**AGENDA**  
**REGULAR ARCHITECTURAL REVIEW BOARD MEETING**  
**Public Meeting Room, Village Hall**  
**Tuesday, May 17, 2016**  
**7:00 p.m.**

3.1 Review of Site Design, Landscape Plans, Building Elevations, Exterior Lighting, Parking, Exterior Signage and Site Amenities for Proposed Redevelopment of the Former Cubby Bear Property for a Banquet Hall, 21657 and 21661 Milwaukee Avenue (Trisha Bumpass & Standard Band & Trust Co.).

**REQUEST FOR BOARD ACTION  
Architectural Review Board  
May 17, 2016**

<b>Subject:</b>	Redevelopment of a Former Cubby Bear Bar Site - Loft 21 Banquet Hall
<b>Action Requested:</b>	Review of Site Design, Landscape Plans, Building Elevations, Exterior Lighting, Parking, Exterior Signage and Site Amenities for Proposed Redevelopment of the Former Cubby Bear Property for a Banquet Hall, 21657 and 21661 Milwaukee Avenue
<b>Petitioner:</b>	Trisha Bumpass & Standard Bank & Trust Co.
<b>Originated By/Contact:</b>	Tonya Zozulya, Economic Development Coordinator Department of Community & Economic Development
<b>Advisory Board Review:</b>	Architectural Review Board

**PROPOSED WEST (STREET FACING) ELEVATION**

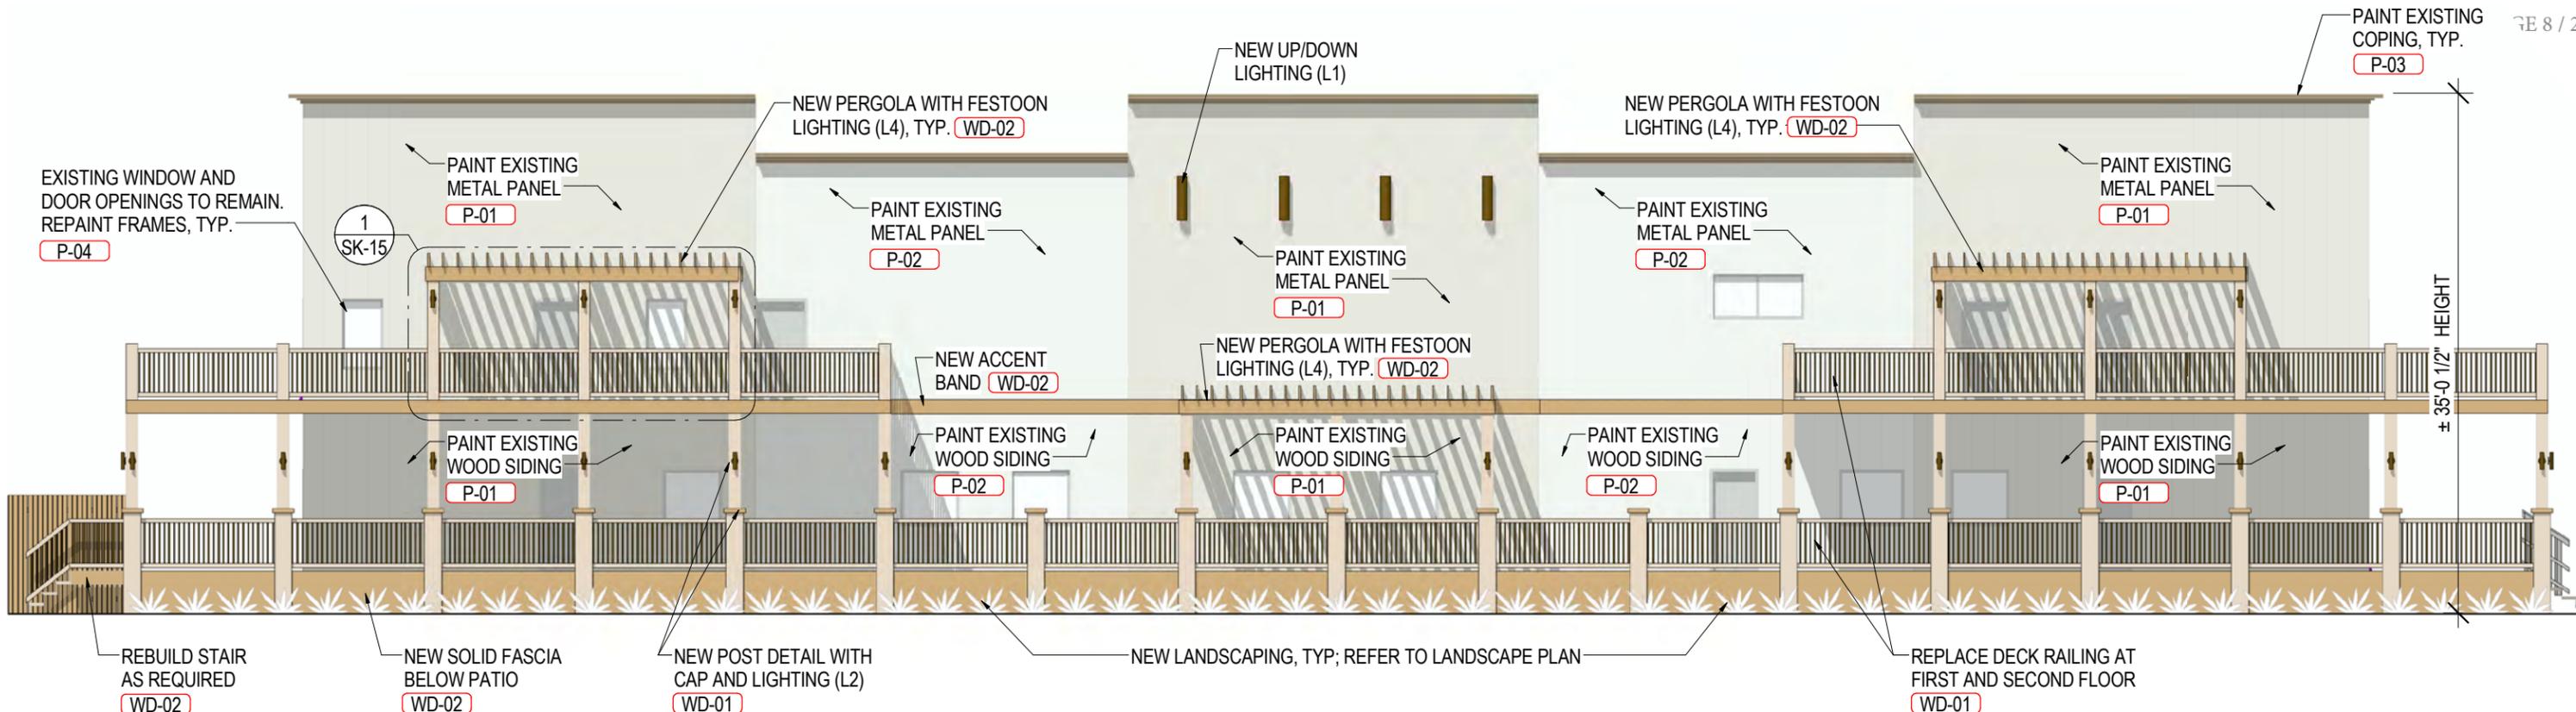
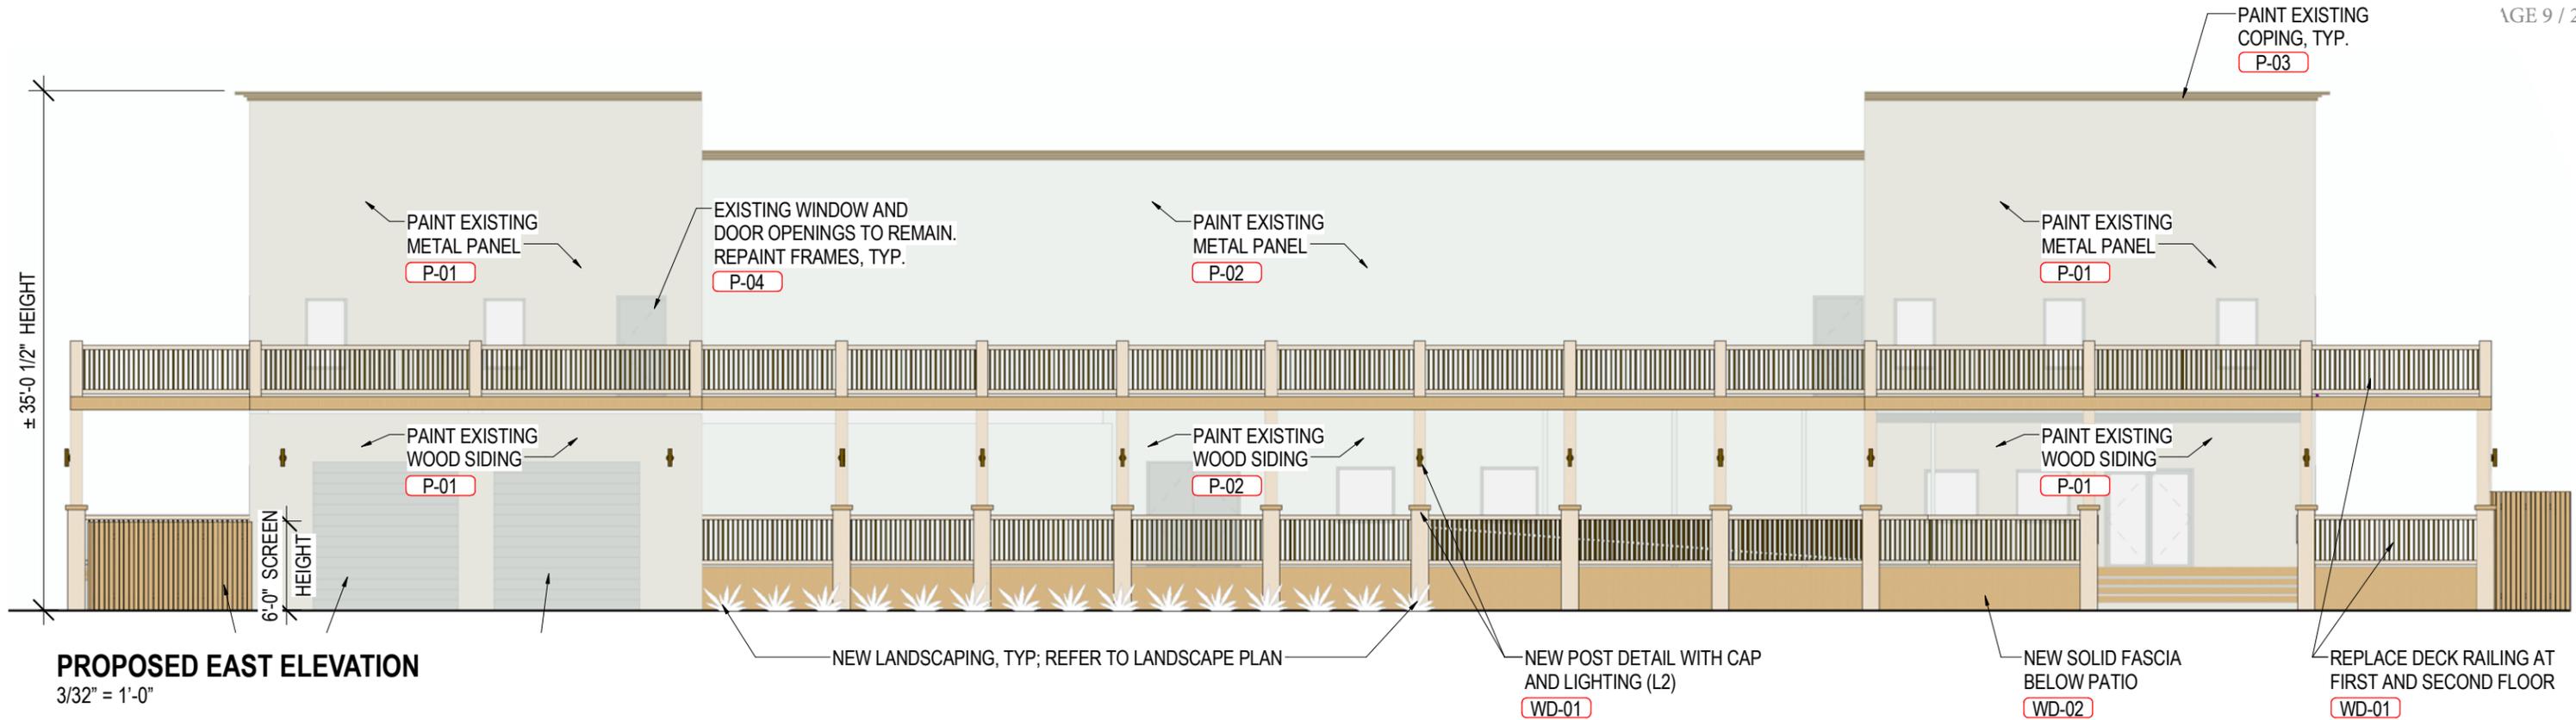
The petitioner proposes to renovate the interior and exterior of the existing building. The existing building materials will be preserved (cedar wood on the first floor and standing seam metal panel on the second floor). The building exterior is to be repainted neutral colors (see attached photos and material/color sheet) and the deck is to be refurbished, stained and improved with a new guard rail and trellises. The existing window and door openings are to remain and the frames are to be repainted. In addition, the refuse area will be screened with a new code-compliant wood plank enclosure in the southeast corner of the building. The existing wall sign and blue awnings will be eliminated and not replaced. Staff believes the proposed building elevations, especially the front façade, lack articulation above the deck area. Staff requested the petitioner consider adding new architectural detailing, such as a raised parapet wall or a wall sign in the middle section of the front façade and banding or lintels on all facades to for visual interest. The petitioner informed us additional architectural elements are not considered due to the fact it is an existing building and due to budgetary constraints. **Staff continues to recommend changes to the front elevation to add visual interest and the addition of architectural details on all four elevations of the building design.** Please note existing satellite dishes are proposed to remain in their current locations until their functions are fully evaluated by the petitioner upon business opening. The petitioner indicated rooftop unit dimensions are not available at this time. The plans do show all rooftop units will be screened with existing parapet walls or code-compliant screens (see attached cut sheets).

1. Consider architectural enhancements to the front elevation and additional architectural details on all four elevations of the building design.
2. Revise the ground sign column material from stucco to brick or stone.

**PROPOSED SIGNAGE ELEVATIONS**  
3/4" = 1'-0"

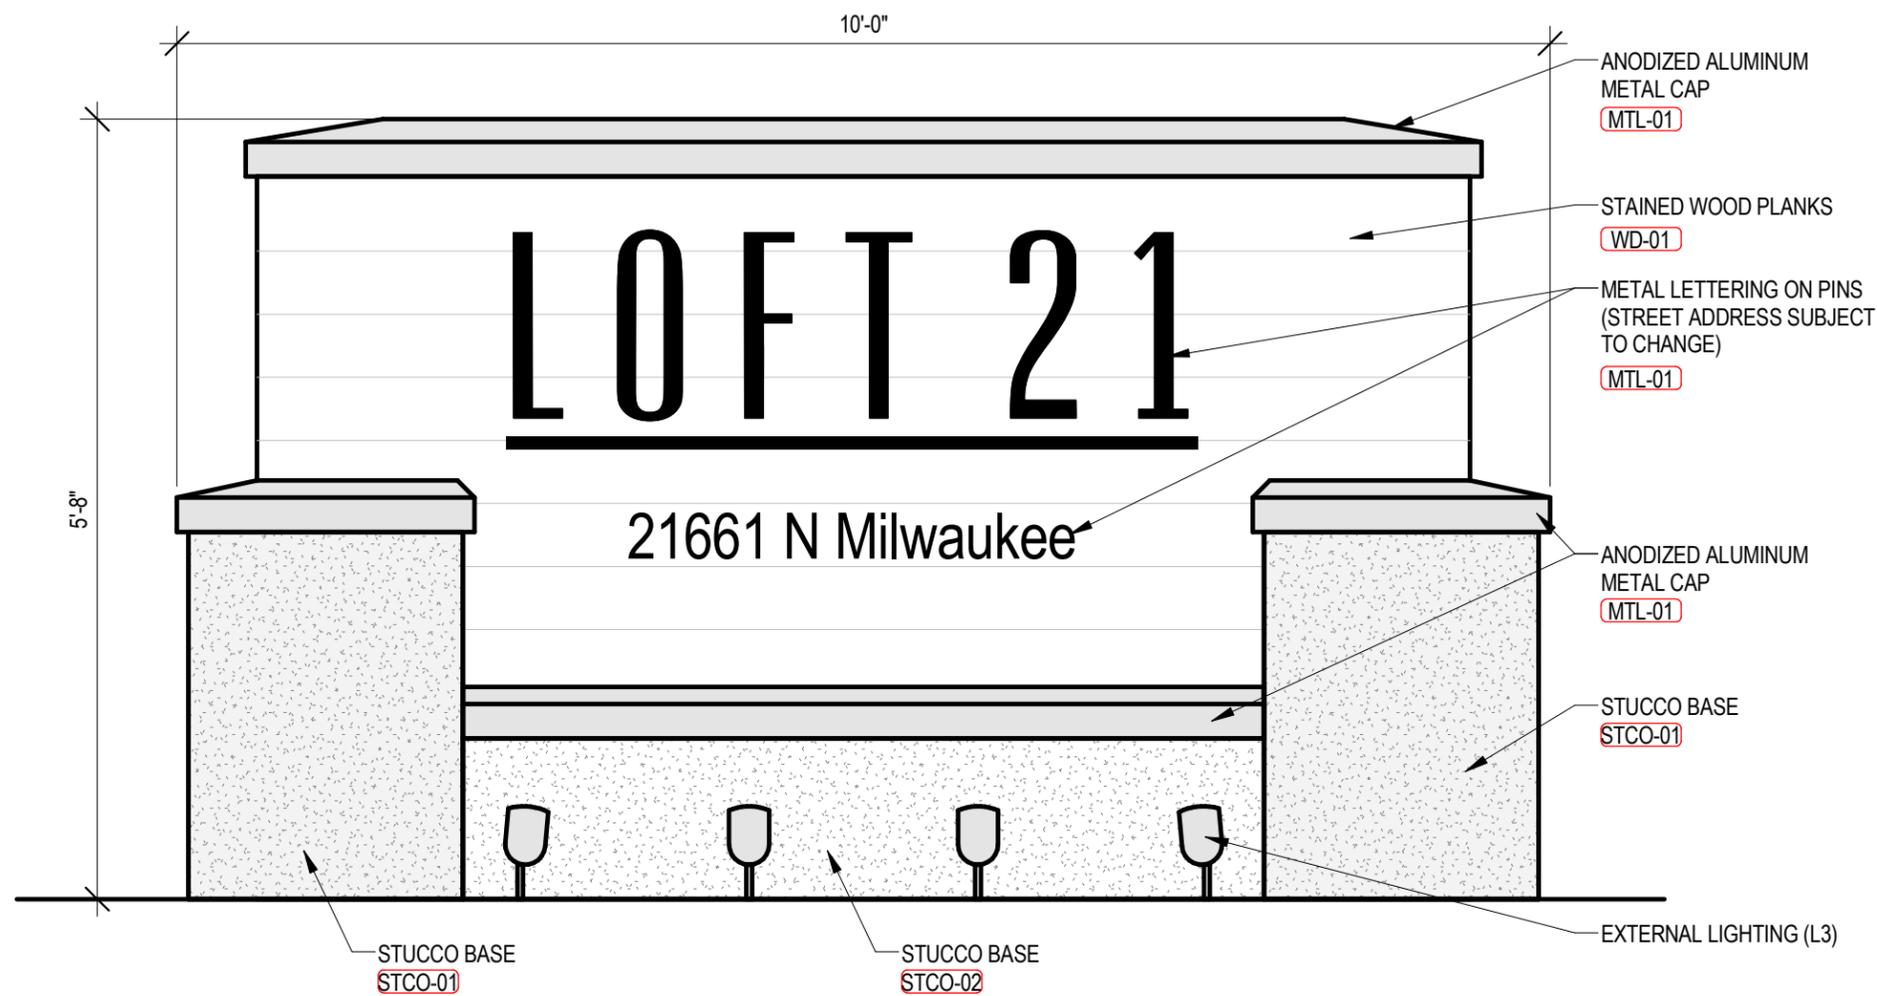
- Exterior Signage  
One ground monument identification sign that displays "Loft 21" is proposed to replace the old Cubby Bear ground sign (see attached renderings and specifications). The sign materials include a wood plank panel, an aluminum metal cap and stucco posts. **Staff recommends another material, such as brick or stone, be used for the posts as the Sign Code allows a stucco sign material only if it is used as a primary building material. Staff requests the ARB consider whether the width of the posts should be reduced for improved sign proportions.** The sign is to be illuminated via external floodlights. Please note the Sign District Map currently does not include this property as it was previously in unincorporated Lake County. In consultation with the Village Attorney, staff determined this sign request should be evaluated according to Corridor Commercial Sign District standards consistent with other adjacent properties with Milwaukee Avenue frontage (staff intends to bring a Sign District Map revision to include this and other newly incorporated properties along Milwaukee Avenue to the ARB along with other amendments in the near future). The proposed sign complies with all Commercial Corridor Sign District standards regarding sign dimensions and setbacks.
